ADDENDUM NO. 3
February 20, 2025

PROJECT: LeRoy Craig Jerome Center
College of Southern Idaho
Jerome, Idaho

Addendum #3 – CSI LeRoy Craig Jerome Center

Date:	02/20/25	To:	LKV Architects
Job Number:	23-319		2400 E. Riverside Drive
Prepared By:	Joe Davies		Boise, ID 83706
Sheet:	1 of 1	Attention:	Greg Bush / Ron Polintan
Project:	<u>CSI – LeRoy Craig Jerome Center</u>

SD3.0A

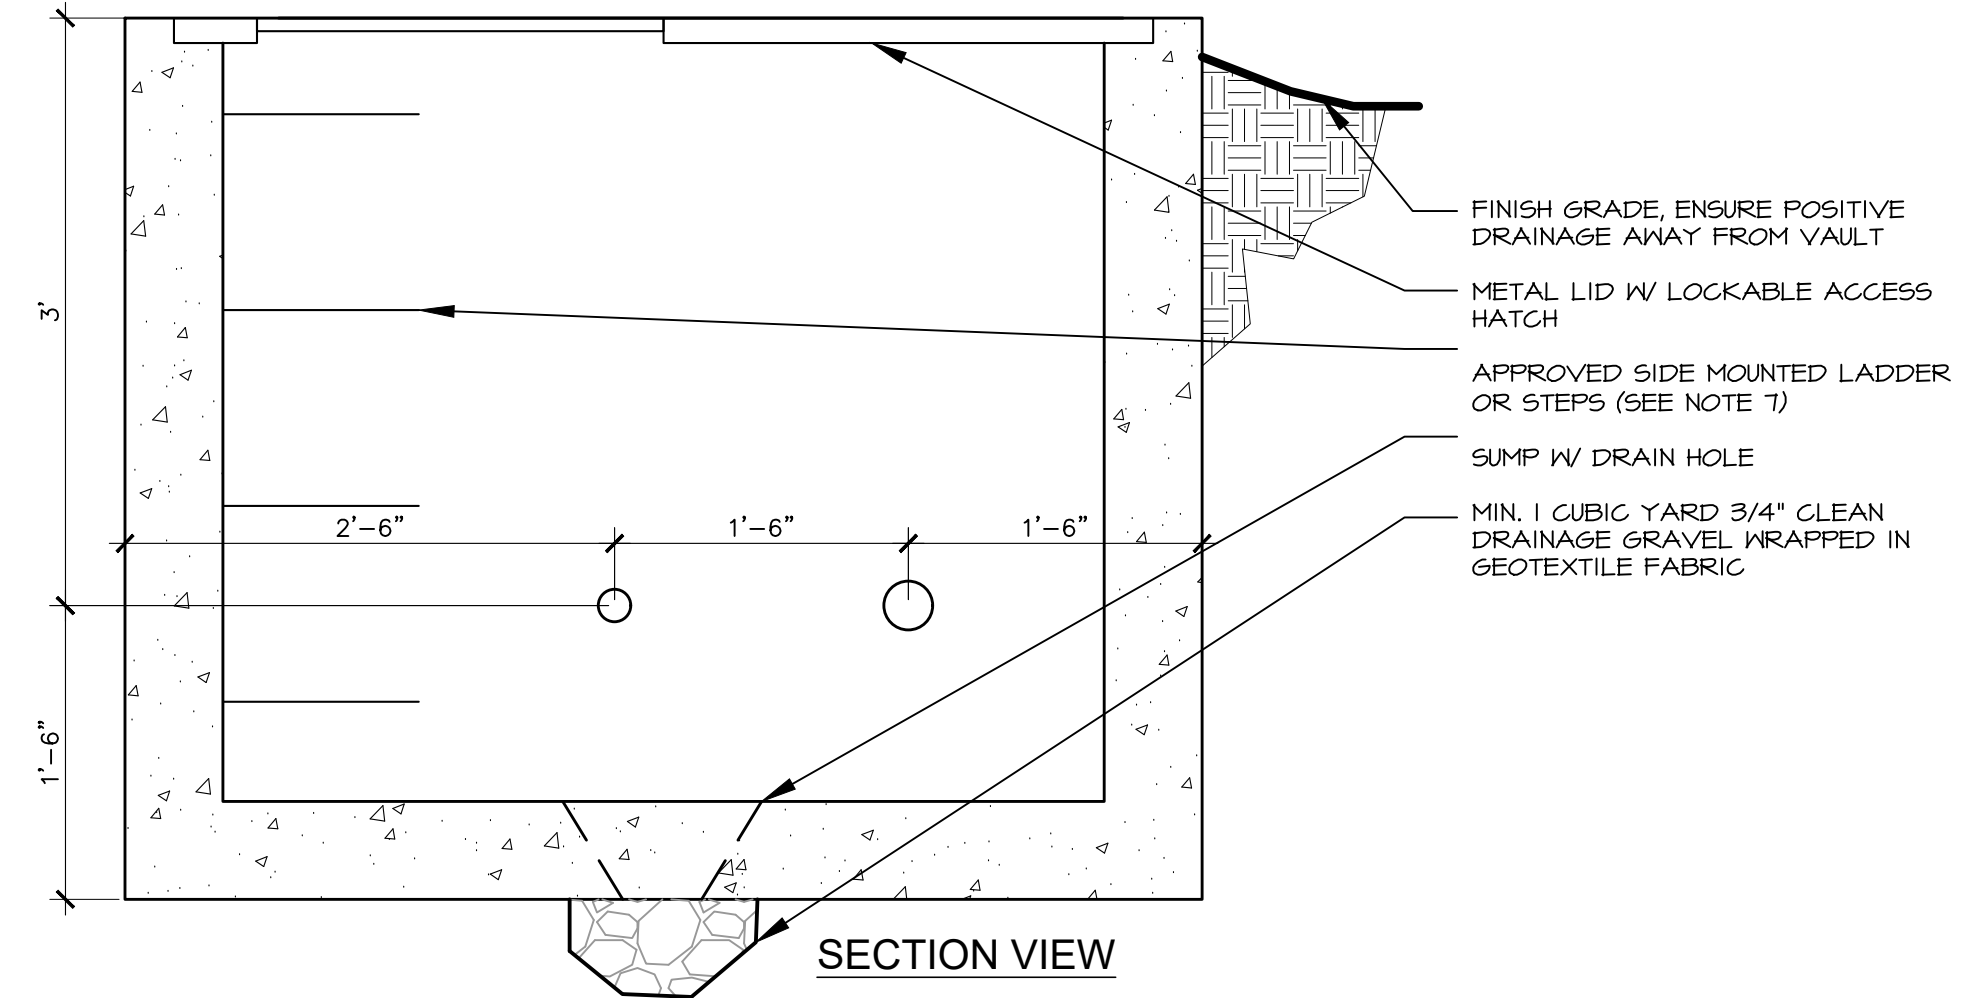
- 1-2 Sheet SD3.0, Add callout 28 for concrete apron at flagpole location.
- 1-3 Sheet SD3.0, Add detail 2 per attached sheet SD3.0A with flagpole concrete apron detail.
- 1-4 Sheet SL2.6, Revise pump station design specifications.

FLAGPOLE APRON

E6.1
PANEL SCHEDULES

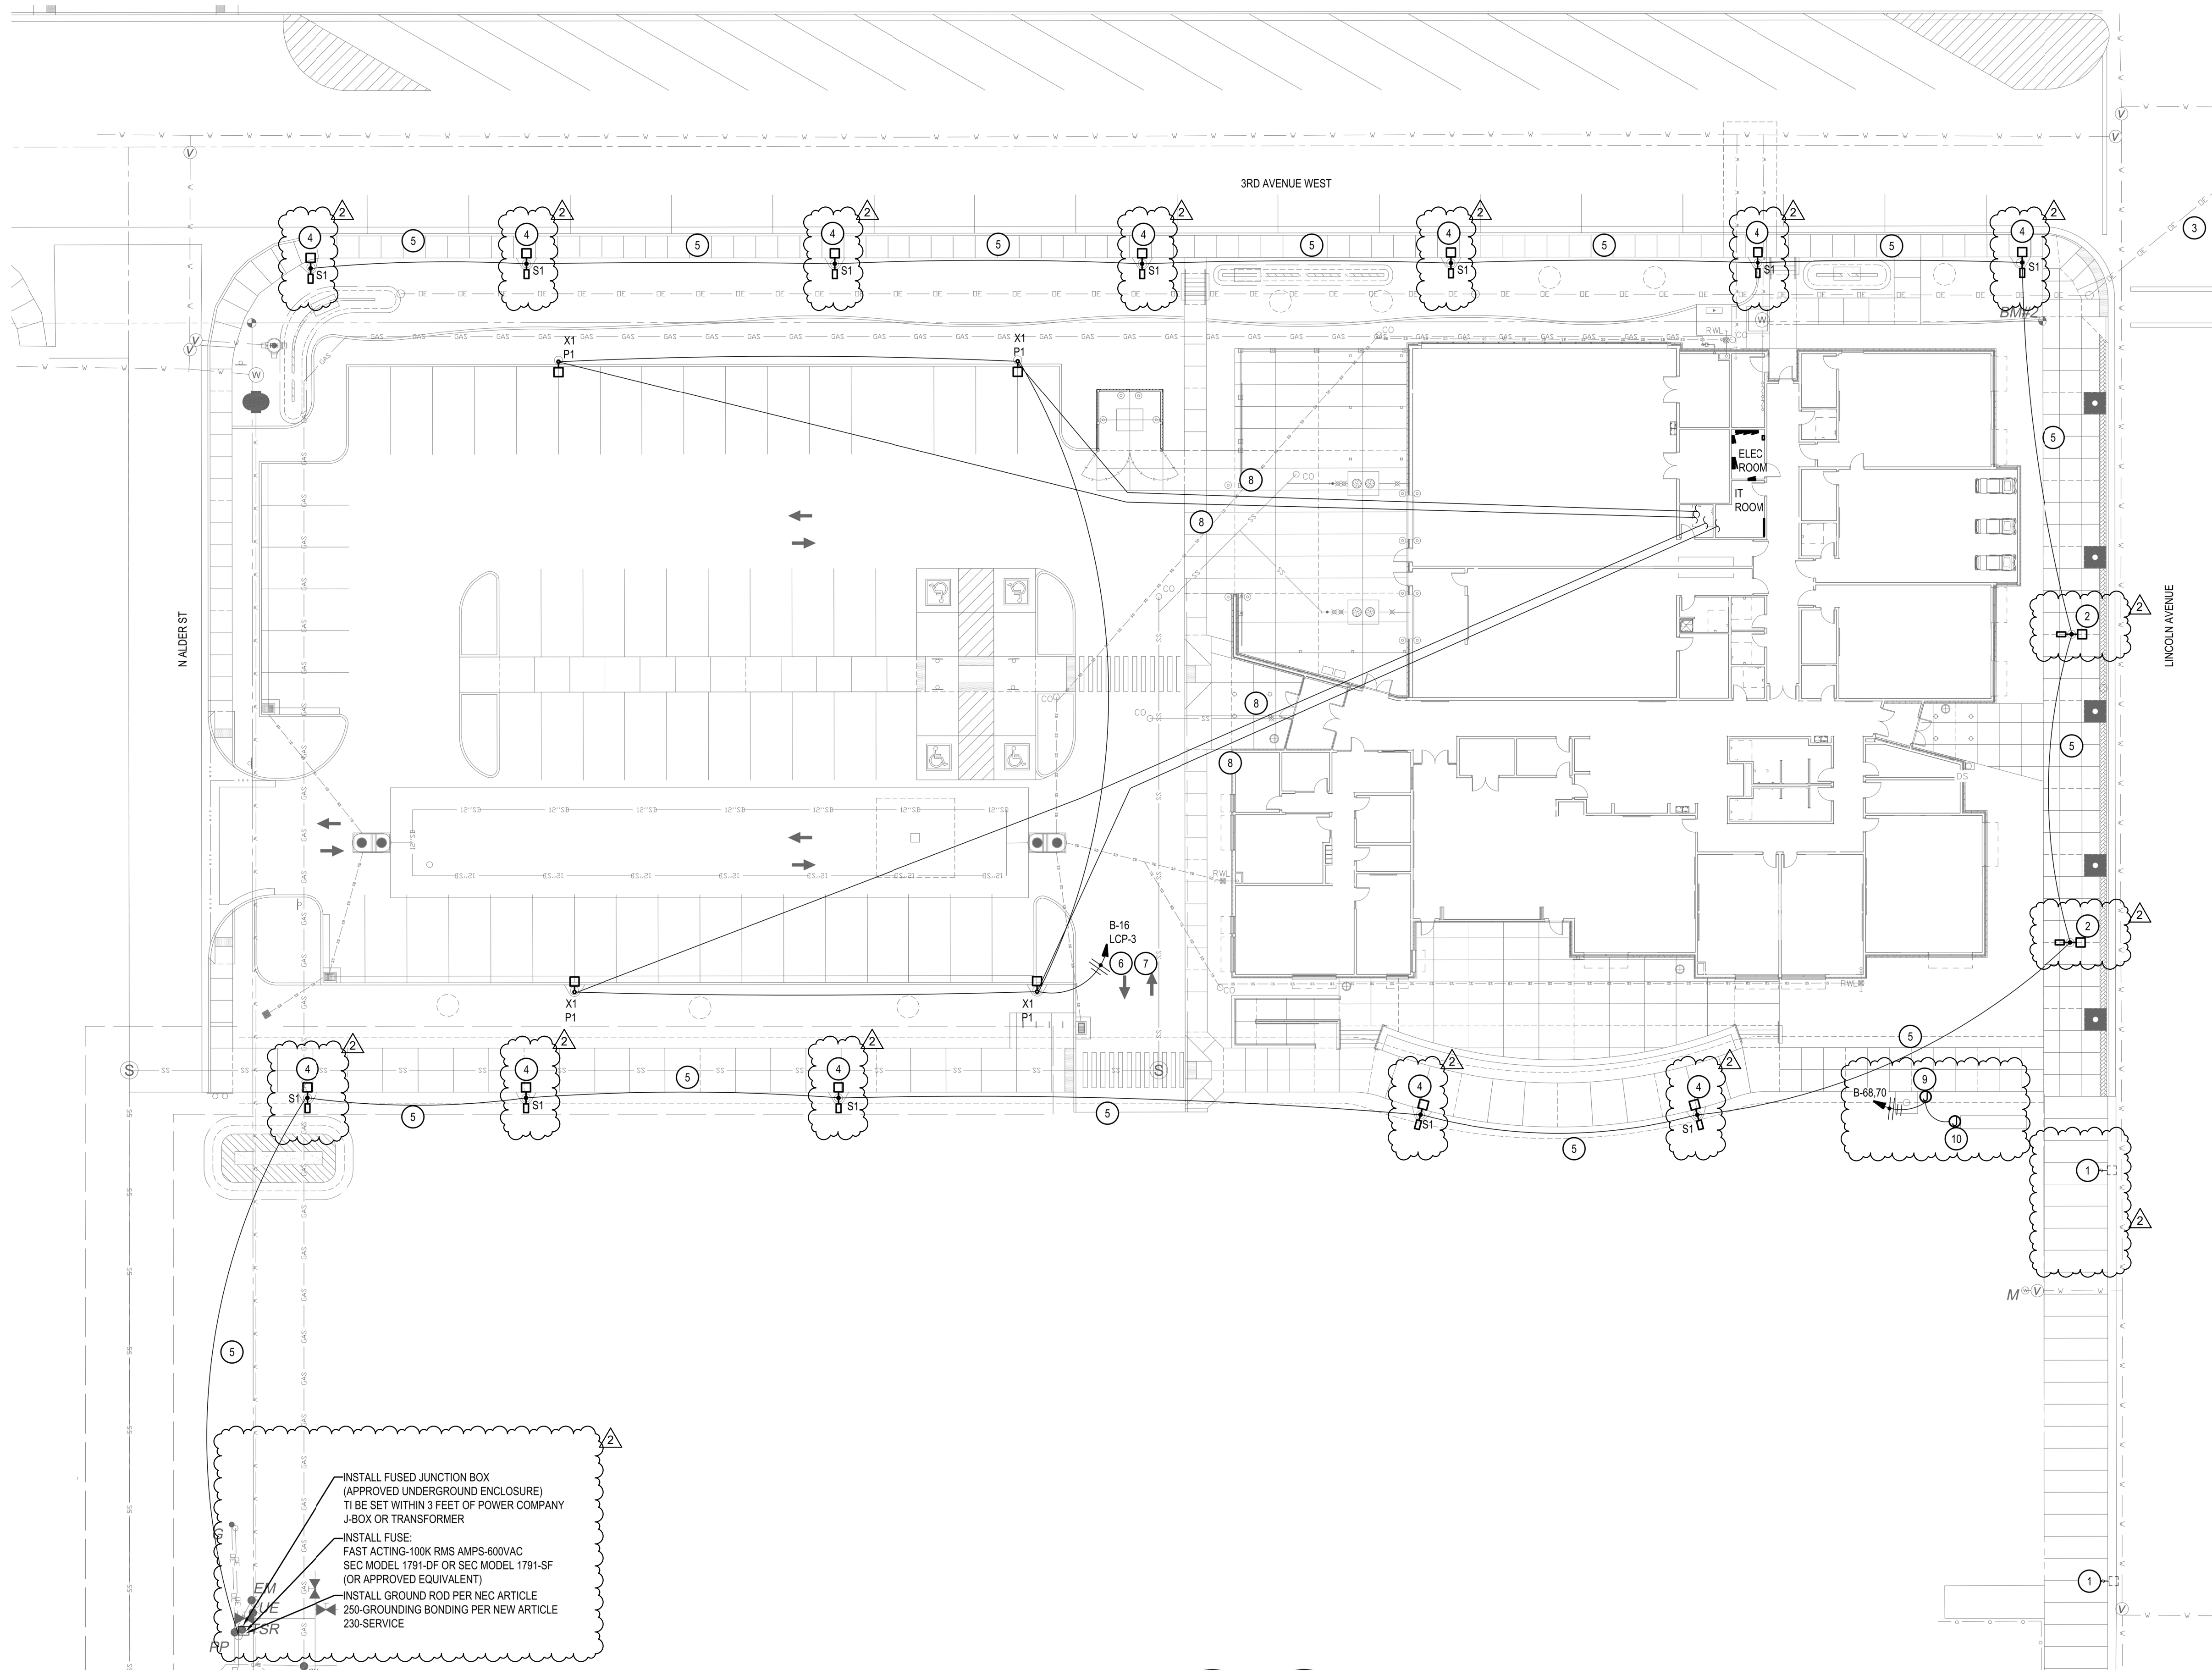
1. Sheet E6.1 updated panel B with new breaker for Marquee sign and flagpole light power.
2. Sheet ES1.0
 - a. Added fuse detail and notes for street light connection
 - b. Added junction box per streetlight required by city
 - c. Added power for future marquee sign and flagpole light
 - d. Updated keynotes for correct contractors per scope
3. Sheet ES3.0
 - a. Updated Site Pole Detail City per city detail
 - b. Updated pole base detail per city detail
4. The following lighting fixtures are approved as equals
 - a. Type G1: 444 Light Beam No: 444-2LED7-MVOLT-SAL-40K-24
 - b. Type G2: 444 Light Beam No: 444-4LED7-MVOLT-SAL-40K-48
